Planning Sub-Committee B

Supplemental Agenda No.2

Item No: 7.	Classification: Open	Date: 22 July 2014	Meeting Name: Planning Sub-Committee B
Report title:		Addendum Late observations, consultation responses, and further information.	
Ward(s) or groups affected:			
From:		Head of Development Management

3.1 Item 1 82 -90 Lordship Lane

Image 7

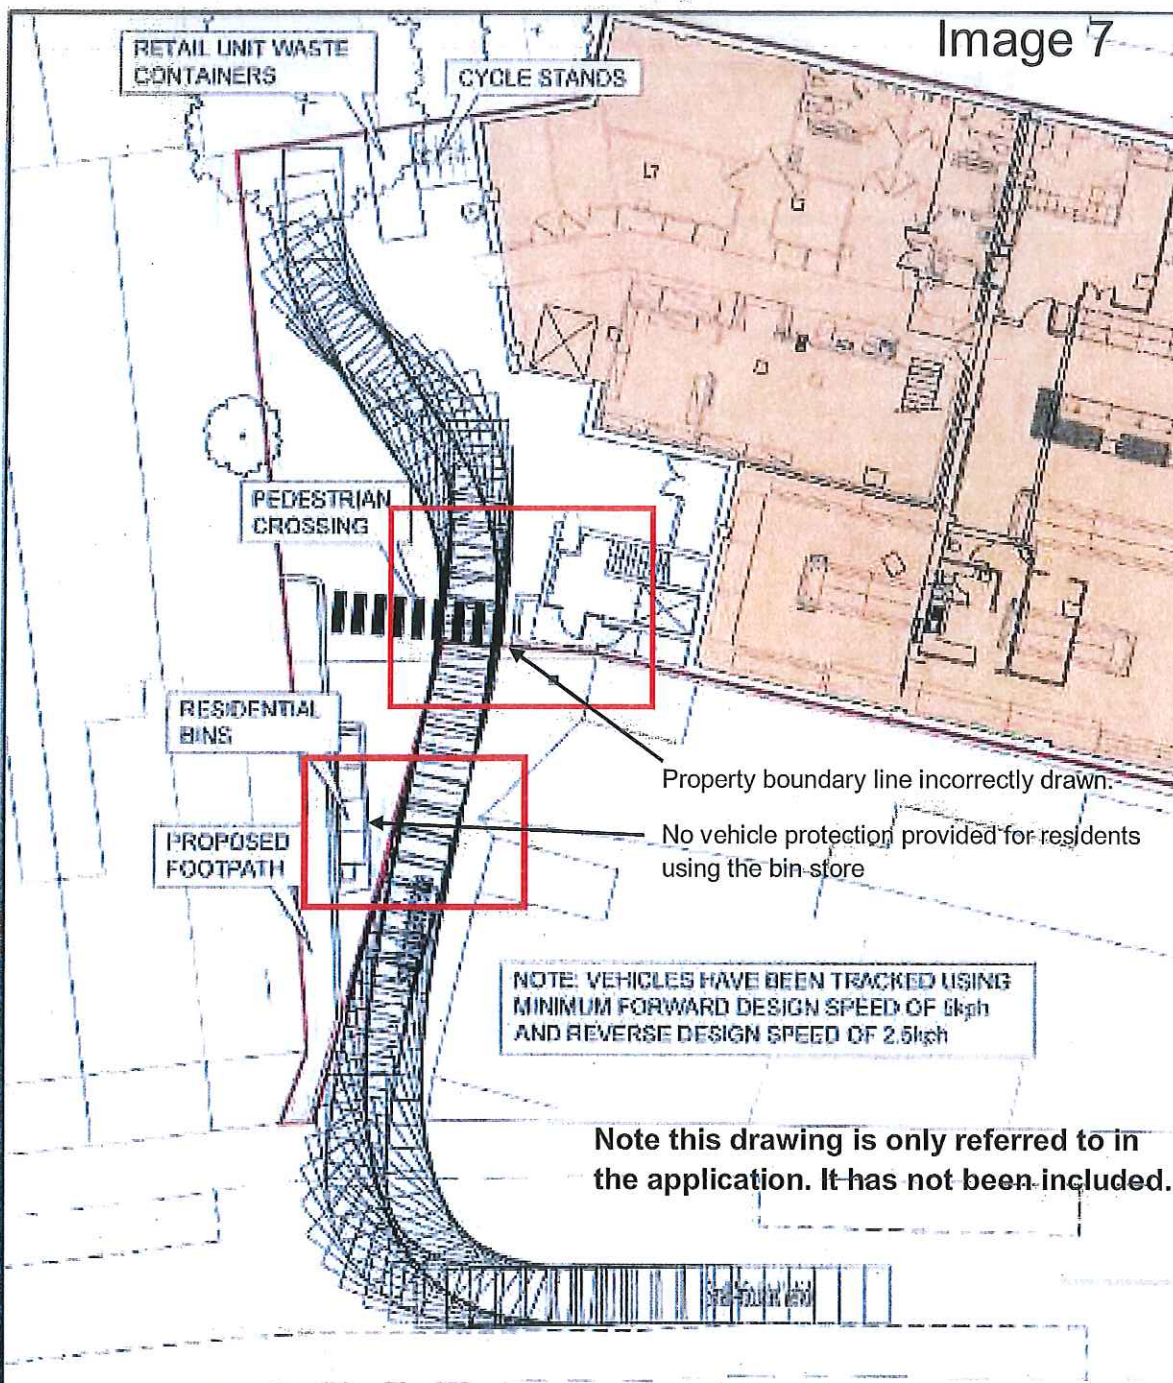
3.07 Image 7 on the next pages shows the current over optimistic swept path. This is only referred to in the application. The red line boundary shown on this drawing is incorrect. The vehicle is shown accessing the parcel of land marked A from tinted brown area, that has no rights of way to, as item 4 recorded in the property register. Ironically the present way the site is accessed is via Melbourne Grove, and this manoeuvre would comply in part with property title restrictions. The restricted access to the bin stores, and the danger that people face when using them from vehicles hitting them because of the lack of room, has been ignored by the traffic engineers drawings, this will be discussed later in the document, section 4 and 8.

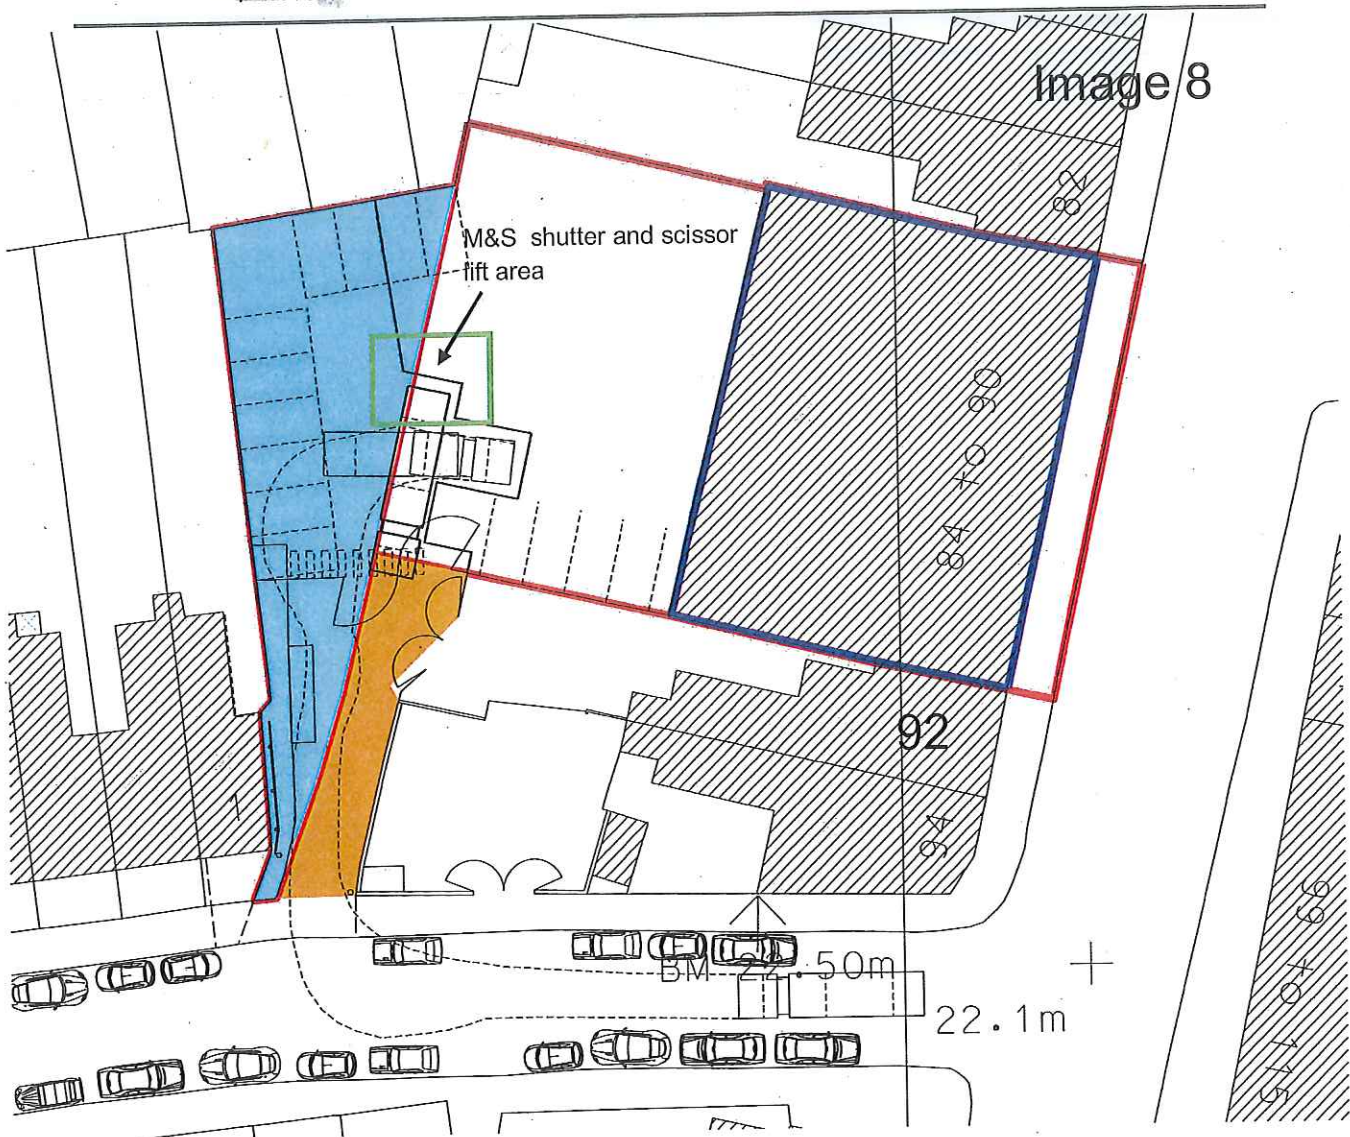
3.07. Image 8 above shows the shutter access to the goods storage. Drawing 1121/P (-) 110 rev P3 notes that there is scissor lift located behind the shutter as required by M&S. For lorry to use this it would have to reverse up to shutter as shown above in image 7. It is noted that vehicle is located such that it blocks access to the flats, and sits on land that only has rights of access over. Also I believe the shutter area is too small to include bollard protection that is an M&S requirement. The architectural drawing should be re-issued to show a vehicle using this shutter with sufficient room for building protection, and not block or endanger residents using the entrance to the flats. To do this would mean the back of house area to the M&S unit would be greatly reduced and no longer fit the store criteria.

Image 11

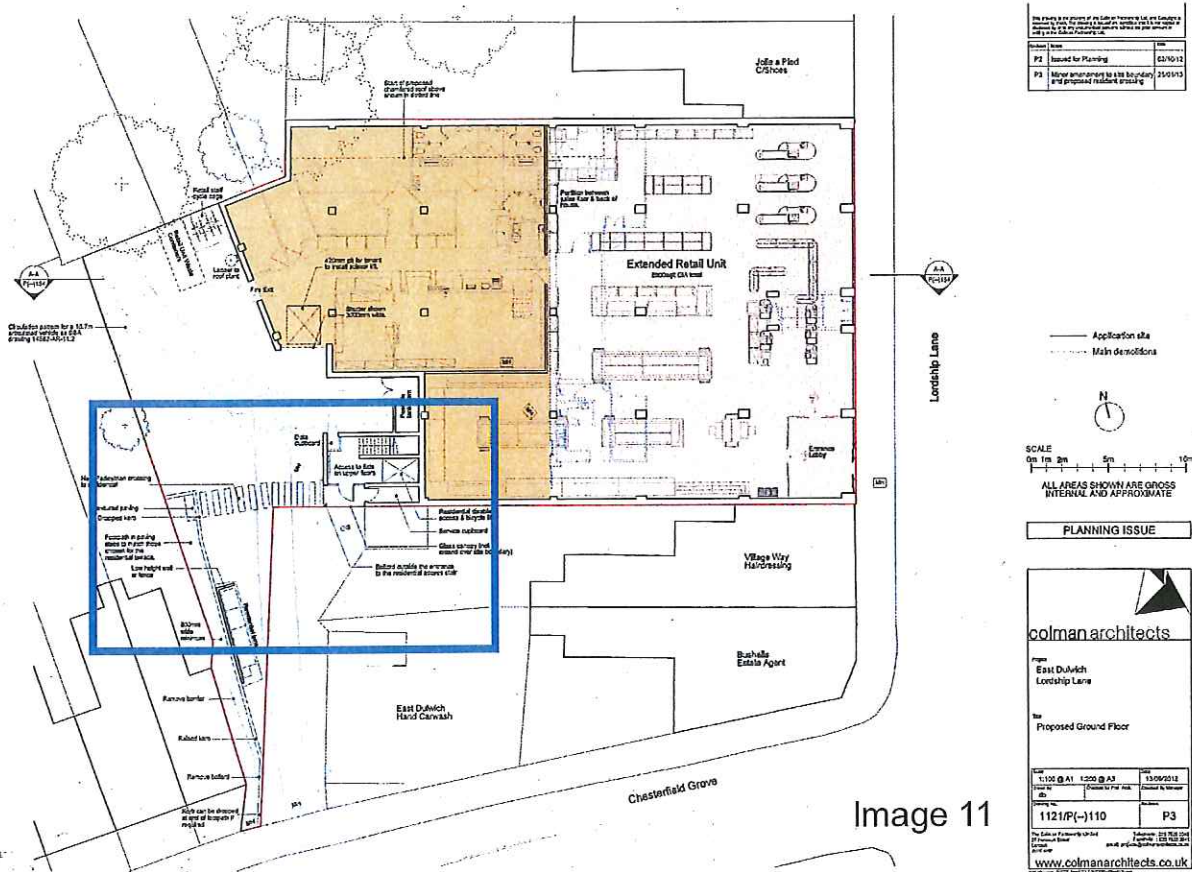
4.02. Item A is an objection to any work being constructed on there land. Drawing 1121/P(-)110 rev P3 (see image 11 on page 17) has been amended from refused application all works is now on the applicants land They also require the entrance of the flats to be located away from their rear vehicle entrance to there property. They consider there is possible risk of residents walking into there entrance and being hit by a car reversing out.

5.02. Drawing 1121/P(-) 110 P2 has the red line property boundary incorrectly shown for 84 to 90 lordship Lane. The applicant has shown works on land that do not own. This has been objected to by the owners of number 92, see section 4.02. Image 11 shows an extract of this drawing below that highlights the error. This drawing should re-issued with the correct title boundary shown on with all items raised in section 4 addressed, as they are mostly to do with title boundaries and rights of way. They must ensure that this drawing reflects accurately the items recorded in the property register for title number SGL 190523, as raised in section 3.

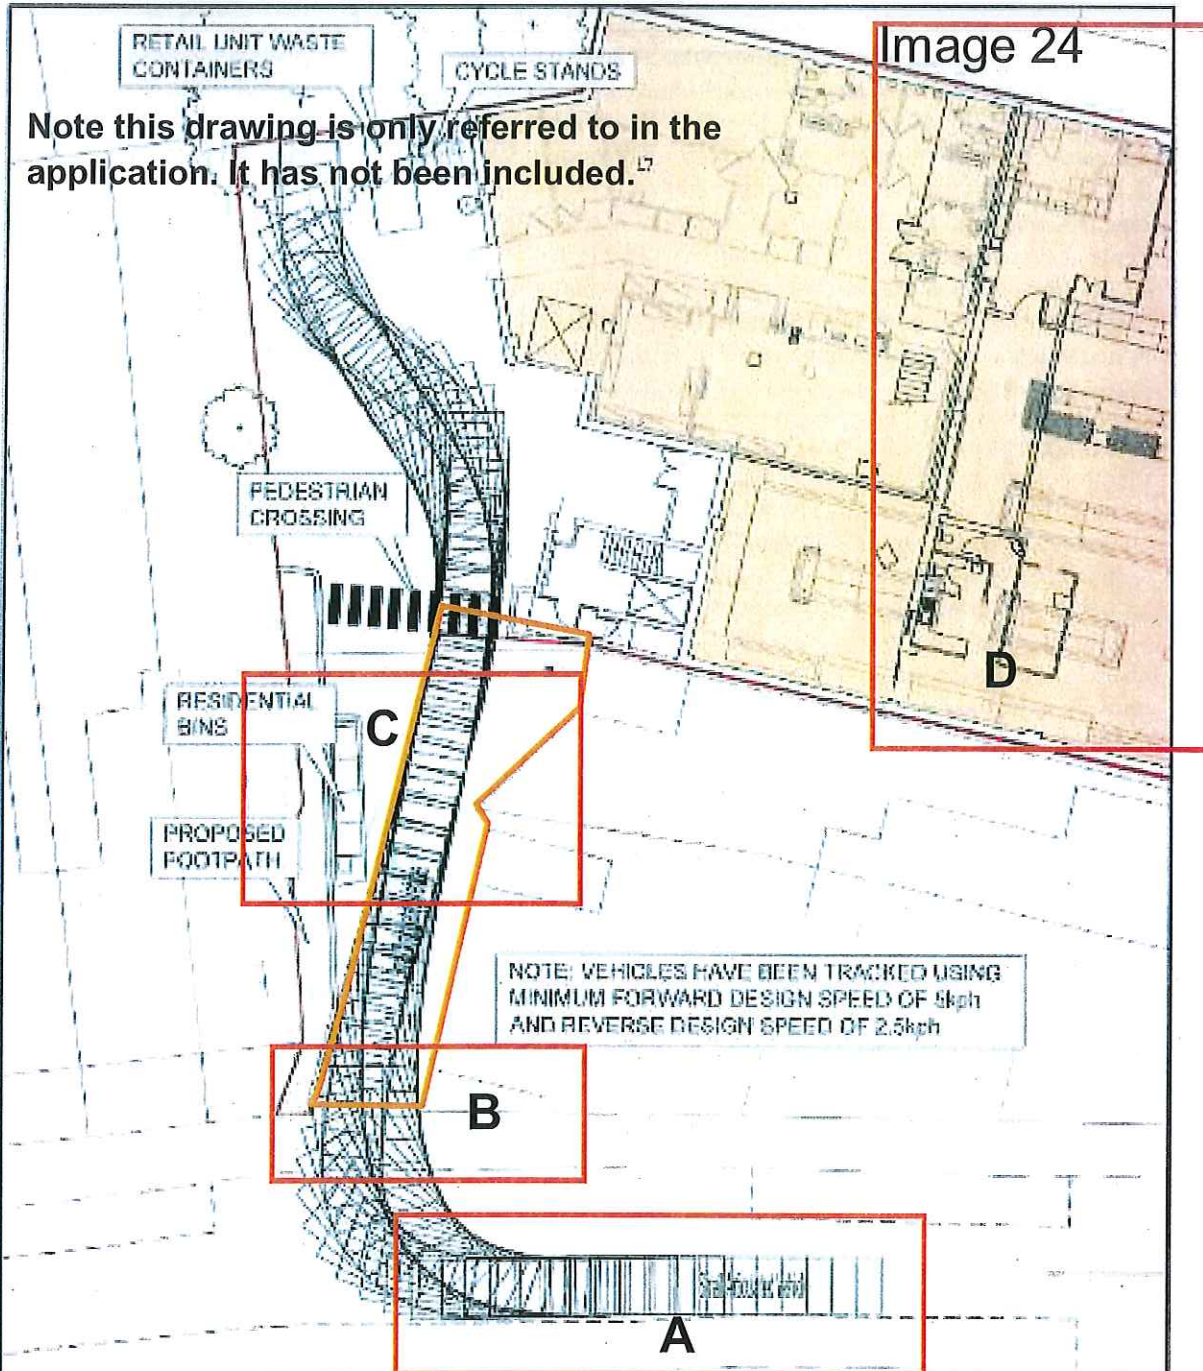
8.03. Image 24 page 27, comments on Drawing 14682-AR-11.1 Rev E. Item A to get into the site the lorry has to positioned itself on the line parked cars. There appears to be very little room for error, and would expect car to be hit on regular basis. If van parked there it would be impossible for the lorry to make it in one manoeuvre. Item B the lorry has mount the pavement to gain access, this is dangerous to any pedestrians , and is illegal. The large bollard protection to 94 has been removed to ease the restricted access. It appears from this swept path that vehicle will hit the corner of this property. Building need to be protected is requirement of the Act. Item C no protection provided to residents using refuse area. The ownership boundary is in correct on this drawing. There is very little room to accommodate a resident with push and children who exit from the flats before they find themselves in the service road. There is nothing to prevent a child from running out from the entrance straight into an on coming vehicles, the design of this area is unsafe. Item D the drawing also show the existing ground floor plan on top of the proposed, this need to be removed.
